**CITY OF EL PASO, TEXAS
AGENDA ITEM
DEPARTMENT HEAD'S SUMMARY FORM**

An Ordinance granting Special Permit No. PZST22-00014, to allow for an infill development with reductions to average lot width, front and side yard setbacks, and a 75% parking reduction on the property described as Lot 17, Block 36, Magoffin, 916 South St. Vrain Street, City of El Paso, El Paso County, Texas, pursuant to Section 20.10.280 Infill Development of the El Paso City Code. The penalty being as provided in Chapter 20.24 of the El Paso City Code.

DETAILED SITE DEVELOPMENT PLAN

CASE NUMBER:	PZST22-00014
CASE MANAGER:	Saul Pina, (915) 212-1612, PinaSJ@elpasotexas.gov
PROPERTY OWNER:	Norma Judith Arrunada
REPRESENTATIVE:	Norma Judith Arrunada
LOCATION:	916 South St. Vrain St. (District 8)
PROPERTY AREA:	0.07 acres
REQUEST:	Special permit and Detailed Site Development Plan approval for infill development with reductions to average lot width, front and side yard setbacks, and a 75% parking reduction for a quadraplex in the A-3 (Apartment) zone district.
RELATED APPLICATIONS:	None
PUBLIC INPUT:	None received as of February 2, 2023

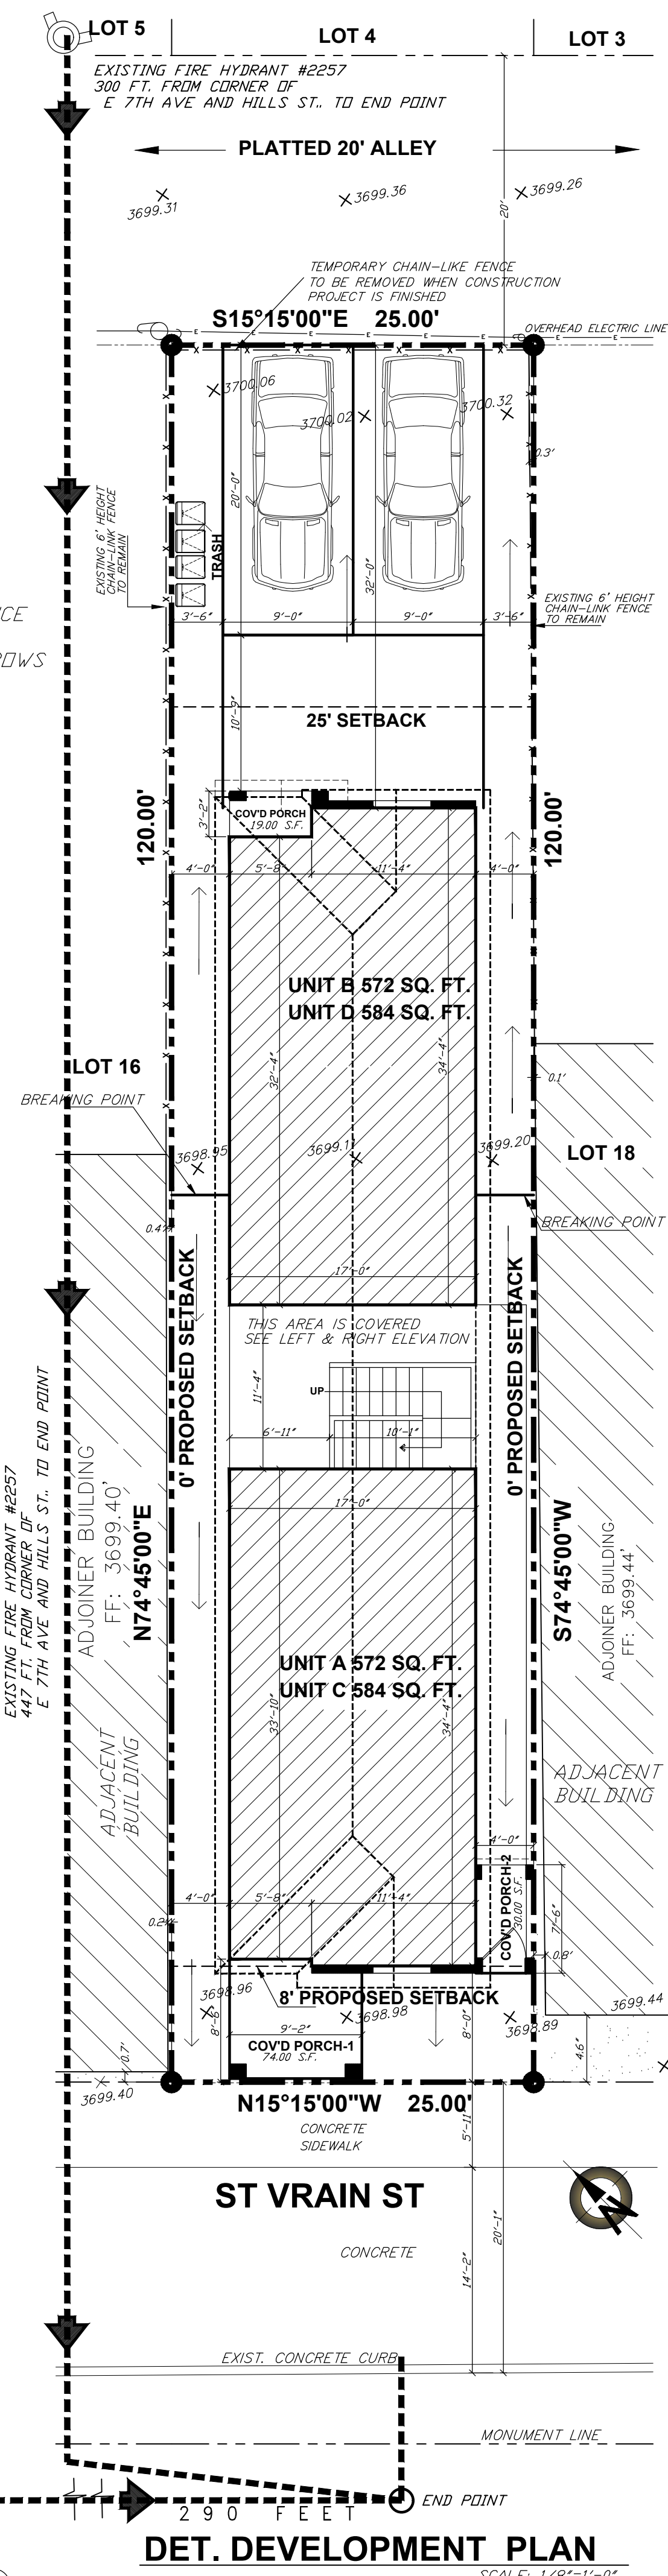
1. Show proposed drainage flow patterns on the site plan and identify the discharge and/or storage location(s) for all stormwater runoff within the subdivision. Show roof gutter runoff discharge locations.

1. Need to show that they meet the hose reach requirements of 150' from fire access. Note: the alley declared may not be used for fire access hose reach determinations. The lot tapering (fencing) to the vehicle parking area looks to be too narrow for hose reach

Note: Comment addressed.

Note: Comment addressed.
